**Report: TAB Report**  
**Function: Test, Adjust, & Balance**  
**Date: 01/12/2026**  
**Completed By: National TAB**

**PROJECT**  
**01-12-26 QT #1412 PHOENIX, AZ**

QUIKTRIP  
4705 SOUTH 129TH EAST AVENUE  
TULSA, OK 74134

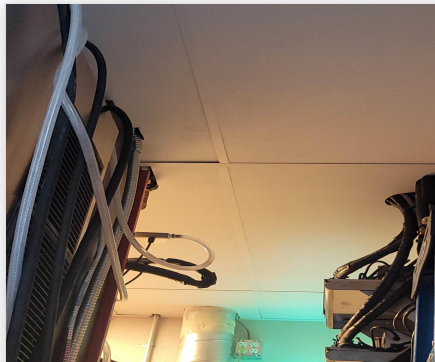
**Issue Name :** BACK AREA NOT BEING CONDITIONED  
**Description :** Duct which should supply damp, humid area behind soda & ice machines is instead atop the ceiling. Problems such as pictured worsen with inadequate air conditioning. Recommend replacing conditioning for the area.  
**Created By :** National TAB                      **Assigned To :** National TAB - Dan Hertenstein  
**Status :** Open  
**Priority :** Medium                                      **Asset Tag :** SGRD5  
**Originated Date :** 01/13/2026 - Christine Weale - National TAB
